# UNITED STATES PATENT AND TRADEMARK OFFICE

APPLICATION NO.	FILING DATE	FIRST NAMED INVENTOR	ATTORNEY DOCKET NO.	CONFIRMATION NO.
10/795,984	03/10/2004	Karp Sik Youn	46178	2260

## Office Action Summary

## DETAILED ACTION

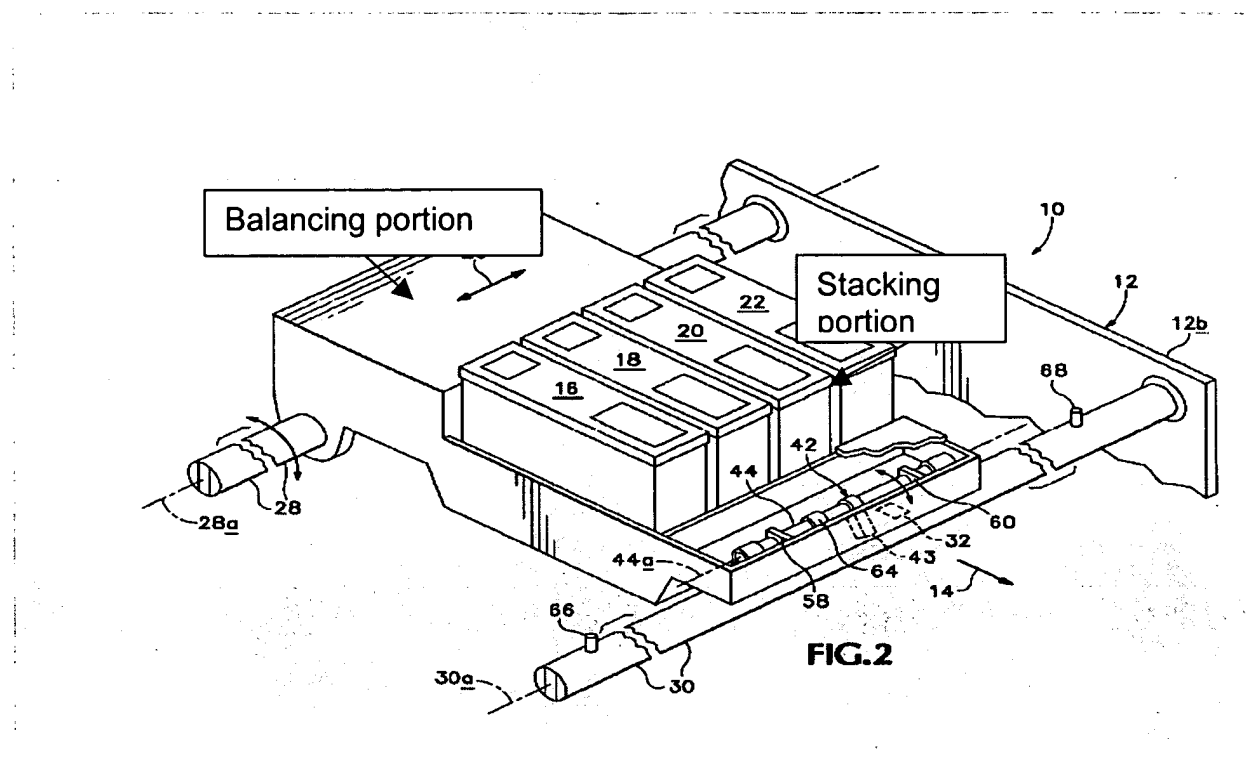
Regarding claims 1 and 15, Kelley et al. teaches a carriage (24), which is rotatably installed on a guide shaft (28,30) and includes a stacking portion (16,18,20,22) cartridge is stacked, and a balancing portion (refer to figure on the next page) installed on a side opposite to the stacking portion, so as to move in a straight reciprocating motion along the guide shaft (28,30) and a head gap adjusting apparatus, which is rotatably installed in the balancing portion and adjusts a head gap by rotating the carriage centering on the guide shaft according to a thickness of a printing medium (Abstract, Column 3, Lines 64-67, Column 4, Lines 1-5 and reference made throughout patent).

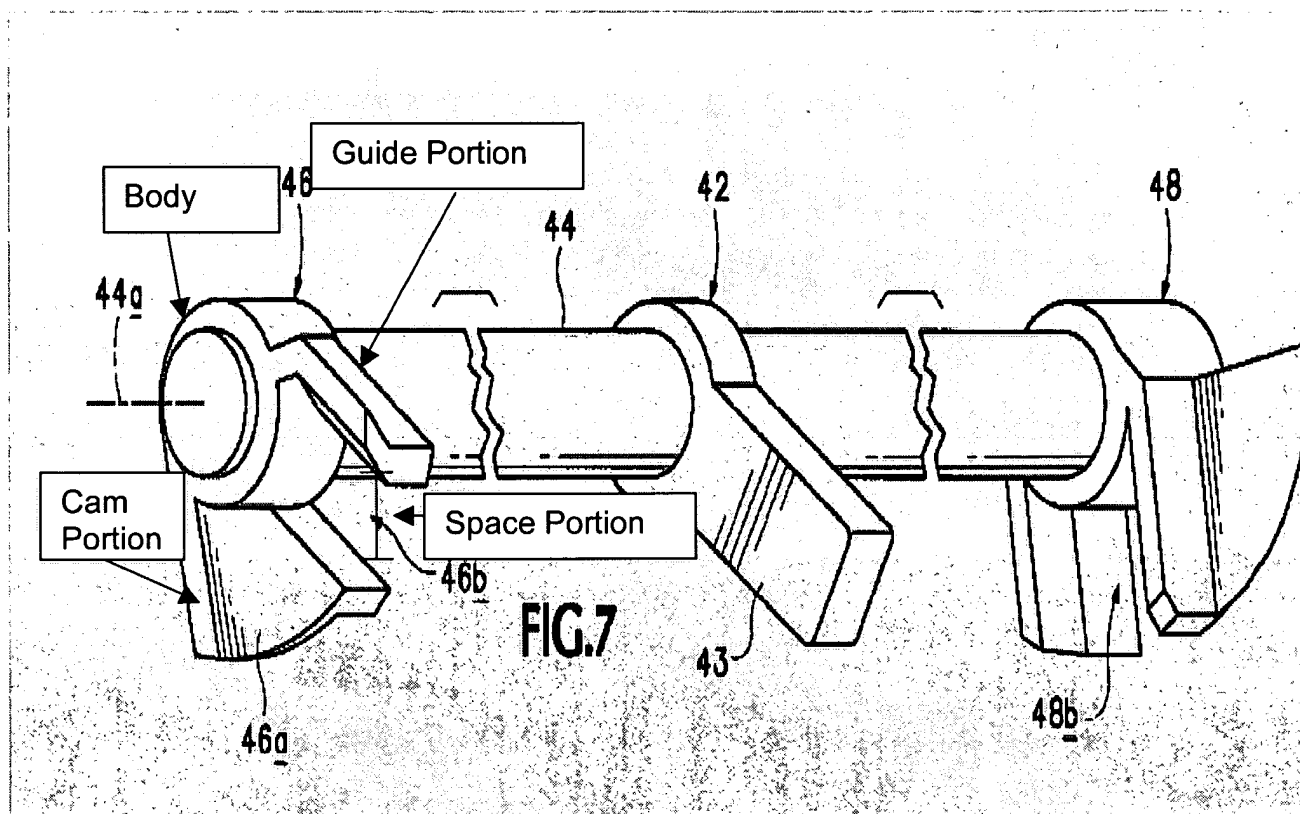
Regarding claims 2 and 18, Kelley et al. teaches a body (refer to figure below), a cam portion (46a), which is provided on one end of the body and in which a cam radius having a predetermined shape is formed, a guide portion, which is provided on the other end of the body and is bent at a predetermined angle (Figures 9 and 10) and a support portion (44), which is provided on a side opposite to a surface in which the guide portion is formed while protruding from the body.

Regarding claim 3, Kelley et al. teaches wherein the cam portion and the guide portion protrude from the body (See figure 7 below).

Regarding claim 4, Kelley et al. teaches a cam portion and the guide portion are formed on the same surface as the body (Figure 7).

Regarding claims 5 and 19, Kelley et al. teaches wherein a space portion has a predetermined height is formed between the cam portion and the guide portion (See figure above).
